# School Safety Assessment Technical Memorandum

Dougherty Elementary School

Dublin Unified School District

Safe Routes to Schools Improvement Plan  
School Safety Assessment held January 2018

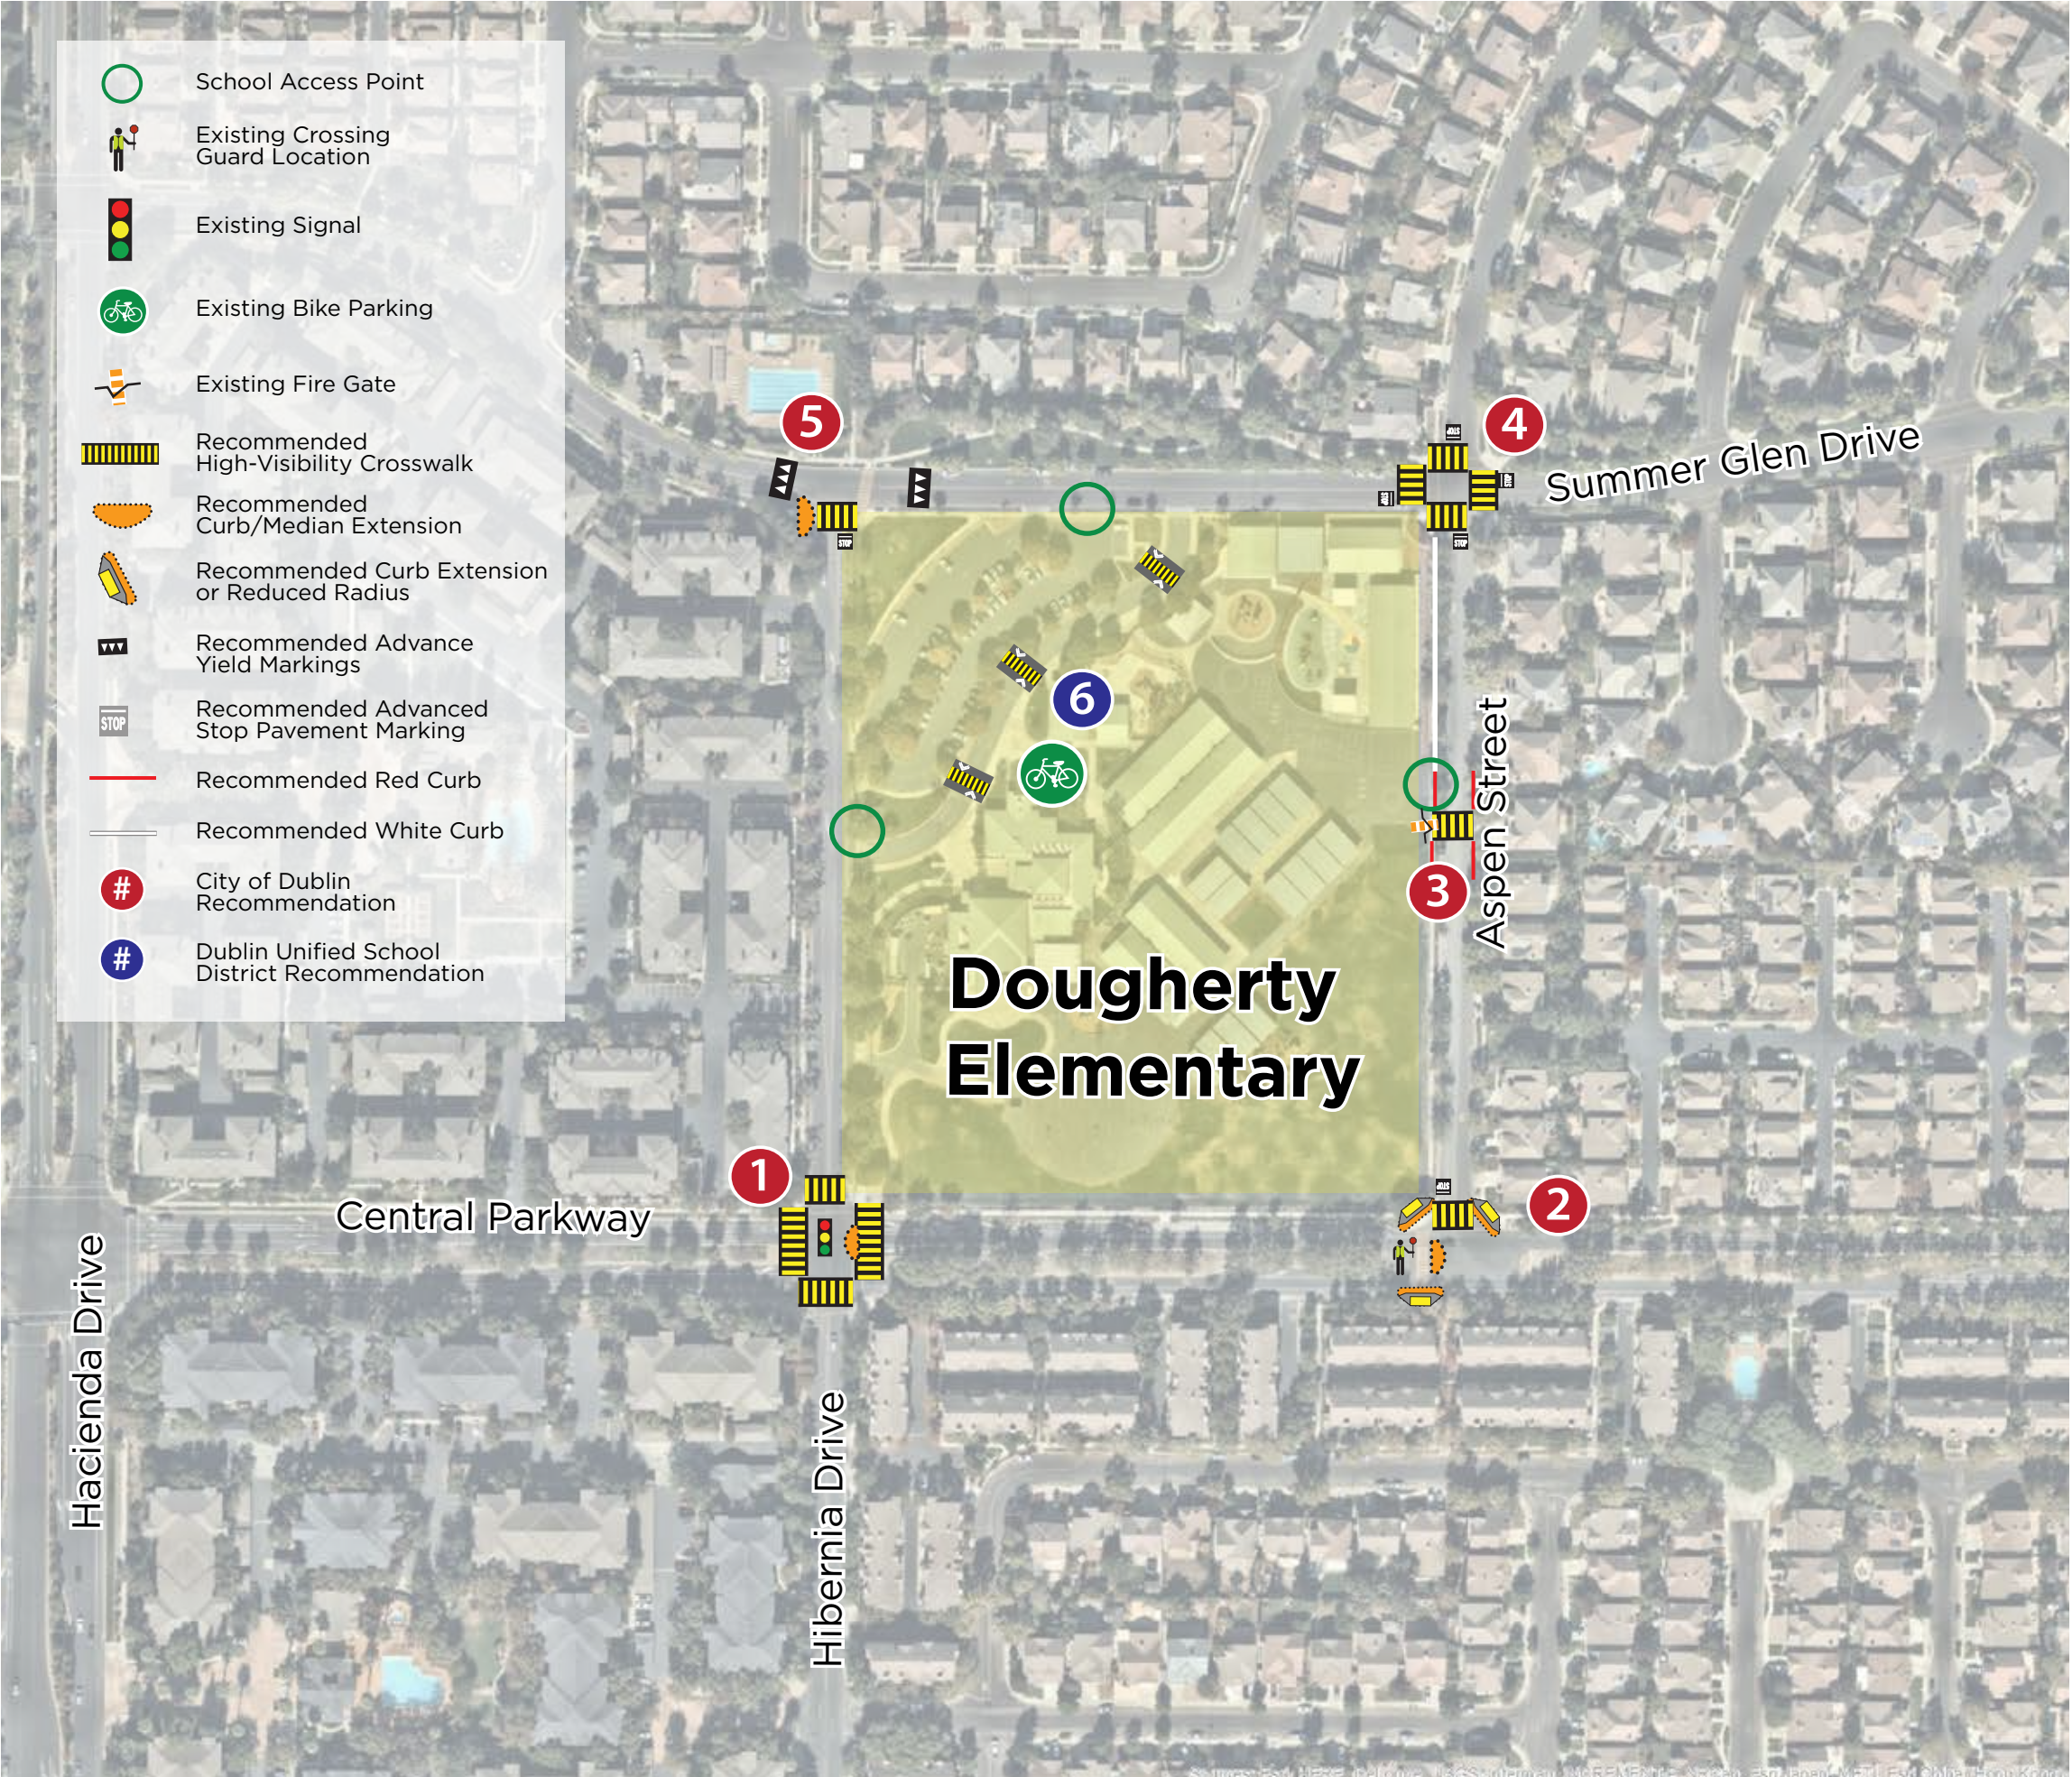
- 1
- Central Parkway and Hibernia Drive**

- Extend median to provide pedestrian refuge island at Hibernia Drive
  - Evaluate crosswalk signal timing to allow additional time for pedestrians as well as Leading Pedestrian Interval to cross at Hibernia intersection
- 2
- Aspen Street and Central Parkway**

- Upgrade existing crosswalk to high visibility crosswalk (already included in City's updates)
  - Extend median to provide pedestrian refuge island at Aspen Street intersection
  - Install curb extension or painted curb to prevent parking close to crosswalk and shorten crossing distance on south side of crosswalk across Central Parkway
  - Install curb extensions or reduce radius for vehicles turning onto Aspen Street from Central Parkway northbound and turning onto Central Parking from Aspen Street heading westbound
- 3
- Aspen Street**

- Consider installing loading zone on northern section to prevent vehicles from parking and allow drop-offs
  - Add signage at fire gate to prevent vehicles from parking and blocking access
  - In coordination with the school, consider installing a midblock crossing with a curb extension and curb ramp on each side to connect the school access point with the residential development. If installed, consider flashing beacon at this location. Install red curb to daylight crosswalk and prevent vehicles from parking too close to crosswalk
- 4
- Summer Glen Drive and Aspen Street**

- Upgrade existing crosswalks to high visibility crosswalks at intersection with Aspen Street and ensure stop bars are properly marked (already included in City's updates)
- 5
- Hibernia Drive and Summer Glen Drive**

- Upgrade existing crosswalk to high visibility crosswalk (already included in City's updates)
  - Consider curb extension or shorter radius heading eastbound at Hibernia Drive to reduce speed of vehicles making right turns onto Hibernia Drive
  - Add advanced yield markings approaching the crosswalks from each direction on Summer Glen Drive
  - Trim vegetation heading eastbound on Summer Glen Drive to ensure visibility of School Assembly sign
- 6
- School Drop Off Loop**

- Short term: Update crosswalks to high visibility crosswalks
  - Long term: Consider installing raised crosswalks
